AMENDMENT OF SOLICITATION/MODIFICATION OF CONTRACT			1 CONTRACT ID CODE See Block #2	PAGE OF PAGES 1 of 4
2 AMENDMENT/MODIFICATION NO 0001	3 EFFECTIVE DATE 29 AUG 2008	4 REQUISITION/PURCHASE REQ NO	5 PROJECT NO (If applicable)	
6 ISSUED BY AEDC PKE AEDC/PKE 100 KINDEL DRIVE, SUITE A-332 ARNOLD AFB, TN 37389-1332 ERIC S YATSKO 931-454-4347 ERIC.YATSKO@ARNOLD.AF.MIL		CODE FA9101	7 ADMINISTERED BY (If other than Item 6) CODE	
8 NAME AND ADDRESS OF CONTRACTOR (No. street, county, State and ZIP Code) TO ALL PROSPECTIVE BIDDERS			(X)	9A AMENDMENT OF SOLICITATION NO. FA9101-08-B-0022
			X	9B DATED (SEE ITEM 11) 30 JUL 2008
				10A MODIFICATION OF CONTRACT/ORDER NO
				10B DATED (SEE ITEM 13)
CODE	FACILITY CODE

The purpose of this amendment is to change bid opening date, provide specification and drawing changes, and provide answers to questions from industry.

ET2

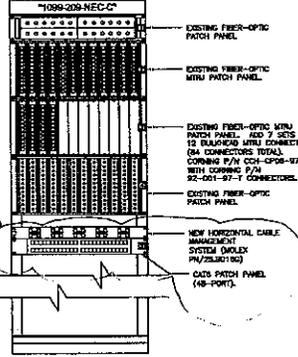
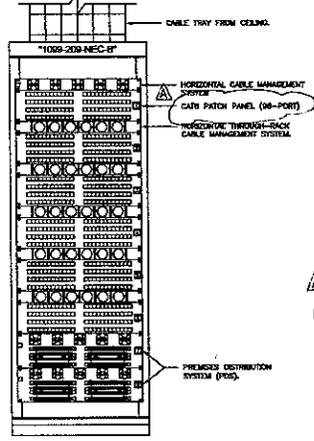
- **Sheet ED2: Cat 5e patch panel will not be reinstalled in cabinet "A". Will instead be turned over to ATA network engineering (NOTE 3).**
- **Sheet ET1: Communication jack changed to 3-port RJ-45 and 1-port MT-RJ, was originally 4-port RJ-45 (Legend). Changed all cat. 5e references to cat. 6.**
- **Sheet ET2: All cat. 5e and cat 5 references changed to cat. 6. Cat. 5e patch panel and cable management system removed from cabinet "A" elevation and replaced with cat. 6 patch panel in cabinet "C".**
- **Sheet ET3: All cat. 5e references changed to cat. 6. All fiber cable labels corrected to reflect the cable type "F".**

Answer: This will affect spec section 16710 and drawings ET1 & ET2. All the CAT5e references should be changed to CAT6 and they will need to include new CAT6 patch panels in their bid (instead of re-using the existing CAT5e patch panels.) **This results in a material change in the specification.**
